Our ref: SPM/Is/14009

6<sup>th</sup> October 2016

**RE: BOVERTON RESIDENTIAL DEVELOPMENT**

Engineering Layout  
Scale 1:250

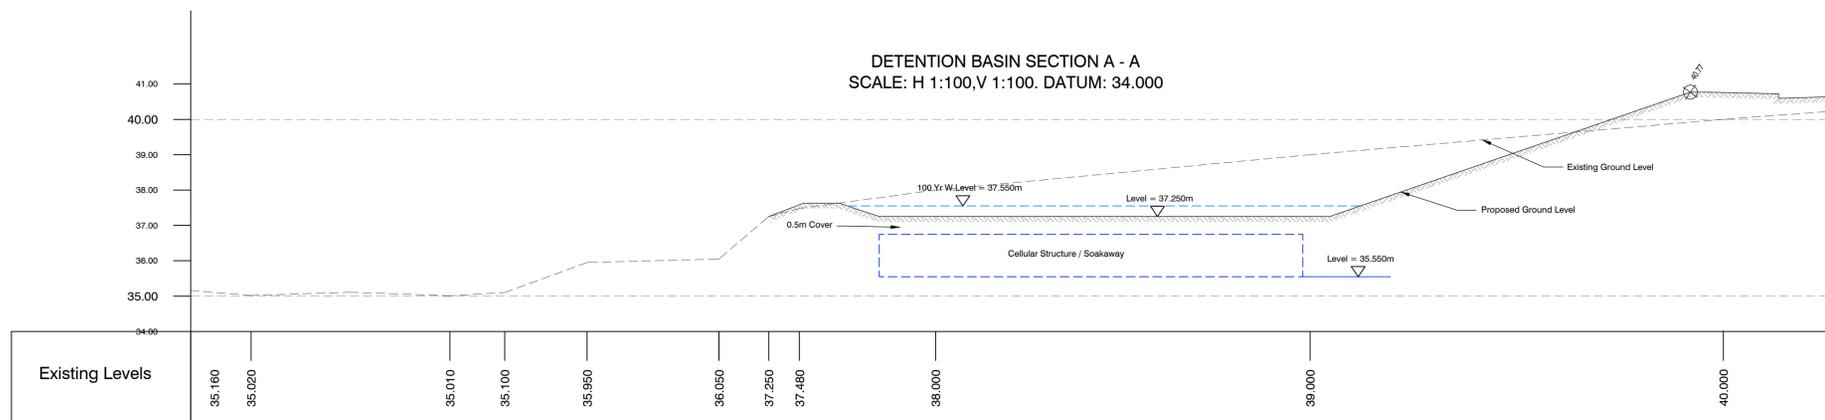
Many thanks for your email dated 28<sup>th</sup> September 2016 requesting further clarification on the SW drainage design strategy. As you are aware we were asked to amend the geometry of the basin very recently to accommodate some layout changes. The basin footprint reduced in plan area although we have since offset this by the introduction of additional porous surfacings within the main development.

We are aware that there are still concerns remaining on the double use of the basin as an infiltration structure/facility and useable amenity area. We have previously stated that perceived excessive water levels within the basin would only occur during the more extreme events when people are unlikely to be undertaking outdoor recreational activities. That aside, we have taken on board the concerns raised in our latest proposals (attached) which now includes for the provision of a buried (cellular) infiltration structure which effectively holds the water below ground whilst it is diffused.

The attached section and calculation illustrates the flood level for the 100 year event to be 300mm (standing water) although this will drain back into the tank within 2½ hours. Obviously, the ground will be saturated for a while until it dries naturally as per any other open space. There should be no ponding for the 1 and 30 year storm event other than naturally occurring depression storage.
